BAR Meeting
May 26, 2010

ISSUE: New Construction

LOCATION: 804 Pendleton Street

BAR CASE #2010-0097

Figure 3: Front elevation.

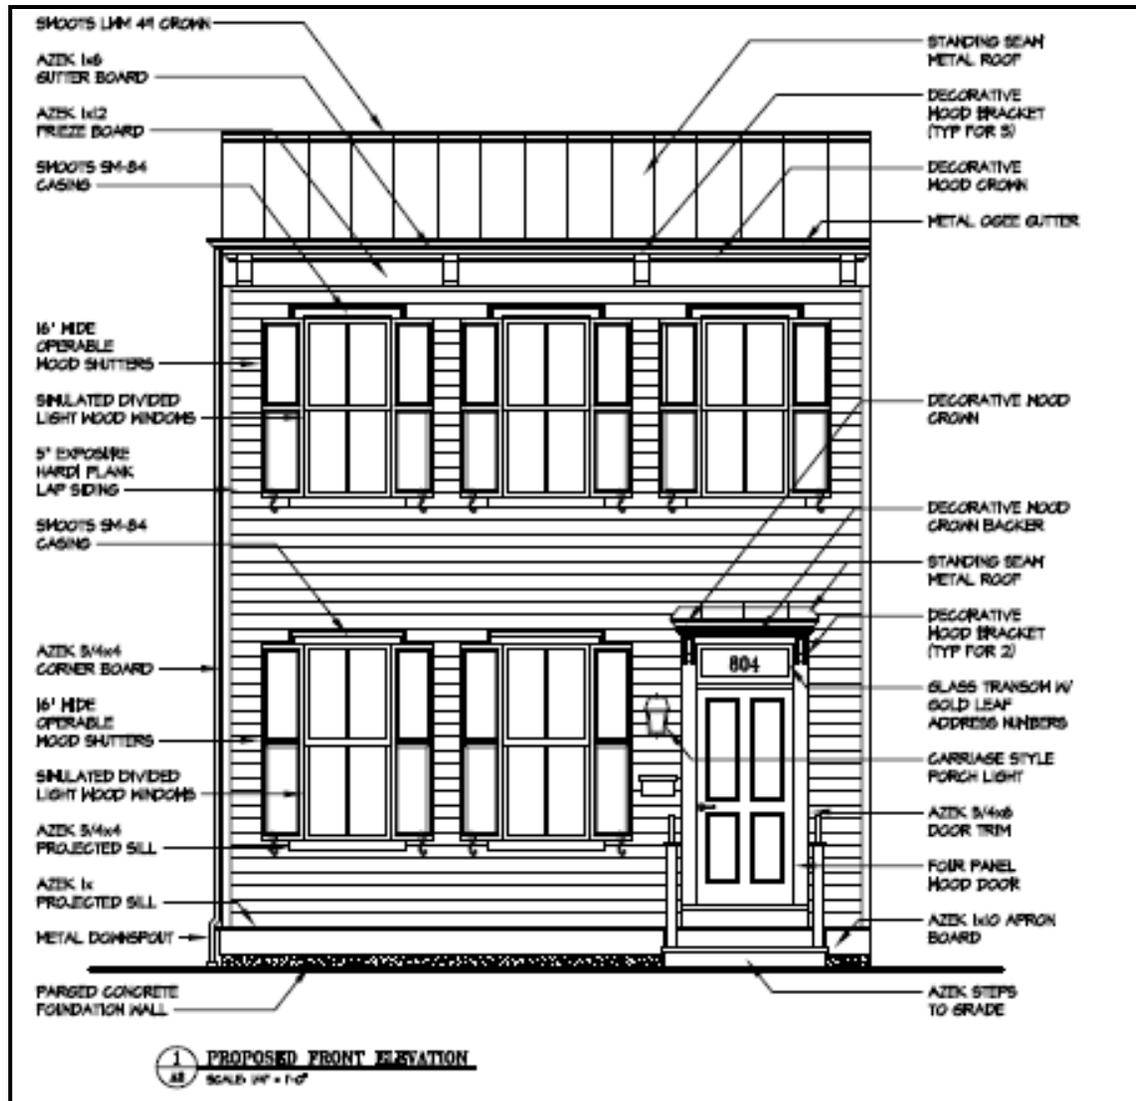
3. That the front stoop be masonry or concrete and not AZEK; and,
4. That the following archaeology conditions shall appear in the General Notes of all site plans and on all site plan sheets that involve demolition or ground disturbance (including Basement/Foundation Plans, Demolition, Erosion and Sediment Control, Grading, Landscaping, Utilities, and Sheeting and Shoring) so that on-site contractors are aware of the requirements:

The front elevation of the townhouse will be three bays wide with a front standing-seam metal mansard roof. On the first floor there will be two two-over-two, double-hung wood windows with simulated divided lights and a four panel front door with a transom. The door surround will include a decorative projecting cornice. A carriage style light and mailbox will be installed adjacent to the front door. The second floor will have three equally spaced two-over-two, double-hung windows. The windows on the front façade will have operable, paneled wood shutters. The trim on the house will be a combination of wood and Azek and the entire house will be clad with 5" exposure HardiPlank smooth lap siding. The foundation of house will be a parged concrete. The front stoop and railing will be constructed of Azek.

Given the period of development for the great majority of the townhouses in Parker-Gray, there are countless front mansard roof forms in the historic districts. Although few retain their original roofing material, we know that they would most commonly have been clad with decorative slate or wood shingles, or stamped metal shingles. Standing seam metal roofs were a more typical treatment on hipped or gable roof forms, not mansard roofs. As such, Staff recommends that the front mansard roof have metal shingles or decorative slate or wood shingles. Historically, although few examples of this molding remain, mansard roofs terminated with a trim piece at the top. Staff recommends that a trim piece, similar to the decorative wood crown, be installed at the peak of the mansard roof.

1. That the mansard roof material be either stamped metal shingles, decorative wood or slate shingles;
2. That the AZEK be solid-through-the-core and paintable;

Figure 4: Detailed front elevation.

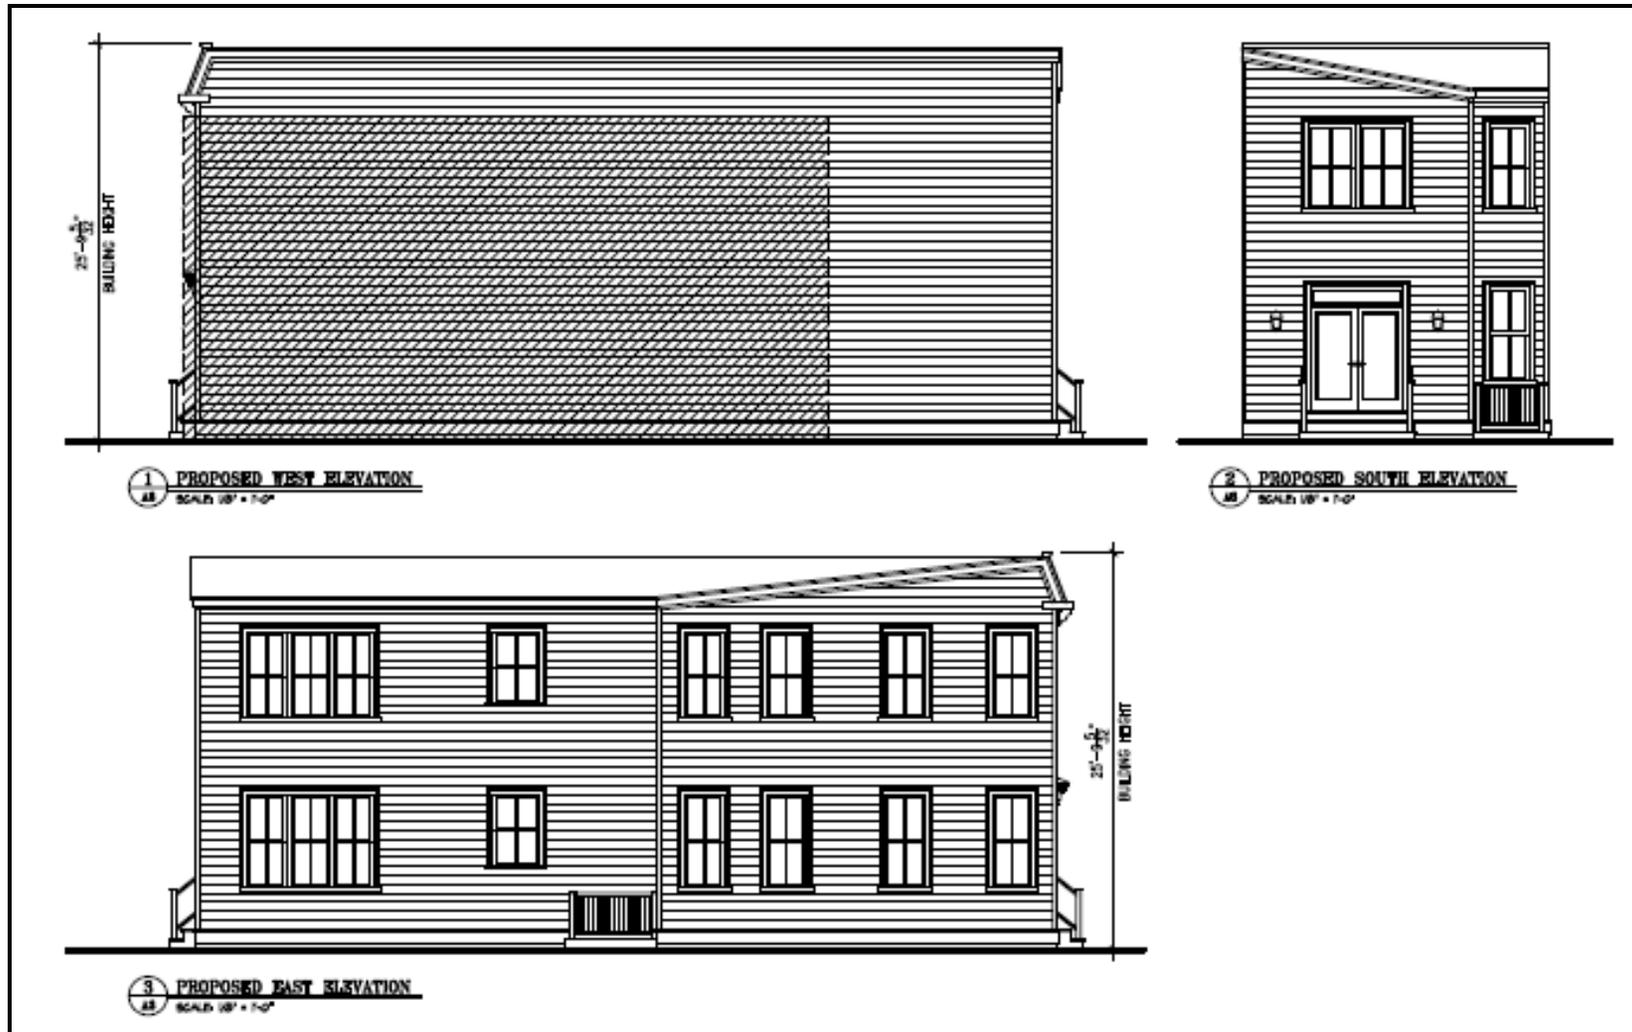
While single-glazed, true-divided-light wood windows are preferable, the *Design Guidelines* and the Board generally allow for double-insulated, simulated divided light wood windows and doors on new construction. The applicant originally proposed a six-over-six muntin pattern which staff believes is inconsistent with the Second Empire detailing on the remainder of the house. The applicant has, therefore, resubmitted drawings to show stylistically appropriate 2/2 windows.

Another benefit of a vertical muntin bar on a 2/2 window is that it will help accentuate the vertical on the rather wide front façade. Staff also requested a minimum 1 ¼” wide muntin to accurately reflect historic window muntin widths.
